**MARIN EMERGENCY RADIO AUTHORITY**

**DATE:** August 28, 2019  
**TO:** MERA Next Generation Project Oversight Committee  
**FROM:** Ernest Klock, Operations Officer  
**SUBJECT:** AGENDA ITEM G: Update on Motorola Change Order #8 – Multi-Protocol Label Switching (MPLS)

Recommended Action: Provide recommendation to be forwarded to the MERA Governing Board regarding the inclusion of Multi-Protocol Label Switching (MPLS) in-lieu of Layer 2 as part of the microwave system for the MERA Next Gen System project.

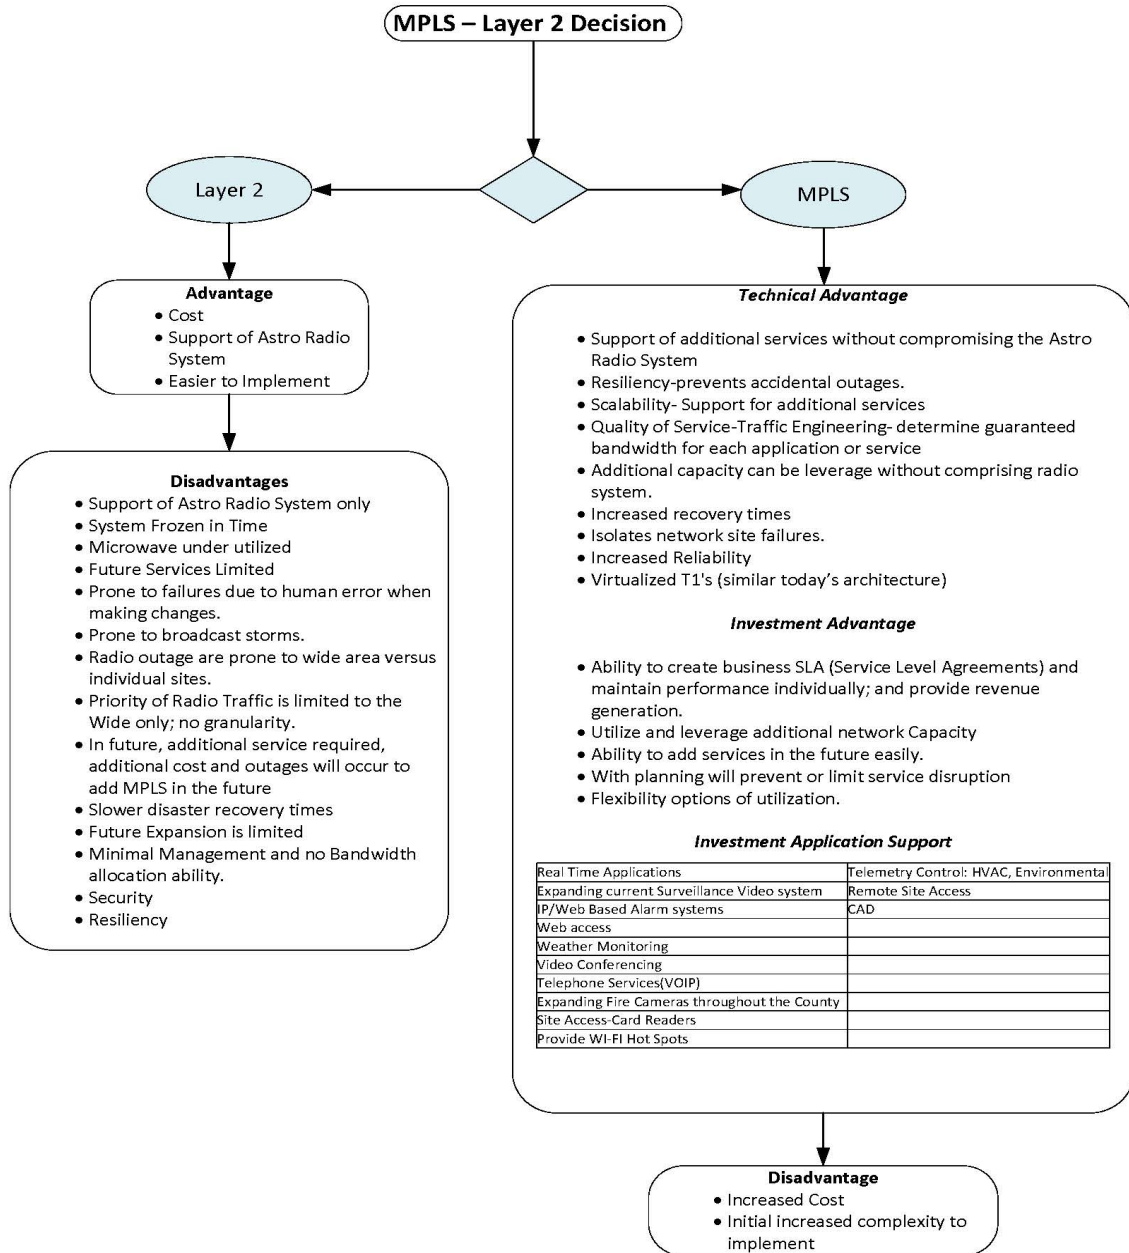
The Layer 2 (Ethernet) equipment proposed by Motorola is a series (one per site) of network switches that creates one data "lane" and does not have the capability to "intelligently" manage the non-LMR traffic. A Layer 2 design can carry normal LMR traffic (made up of small bursts of data), but it cannot carry larger data packets such as video traffic, or CHP or FBI circuits without increased system vulnerability (due to feedback loops). In addition, the Layer 2 option is not as scalable when creating larger networks, or "broadcast domains", and the performance degrades if it is configured as such. Motorola cannot guarantee system performance if Layer 2 is configured to carry the non-LMR traffic, so MPLS should be used if accommodation of these services is to continue.

Unlike the Layer 2 switches, the MPLS equipment is a series (one per site) of network routers that create several data “lanes” and can be configured to route each of the non-LMR services independently. Therefore, the LMR voice traffic can be isolated from the other non-LMR services to guarantee mission-critical voice is always available. A design using MPLS will increase the redundancy, reliability, and future flexibility for the NextGen System. The following diagram compares the two technologies.
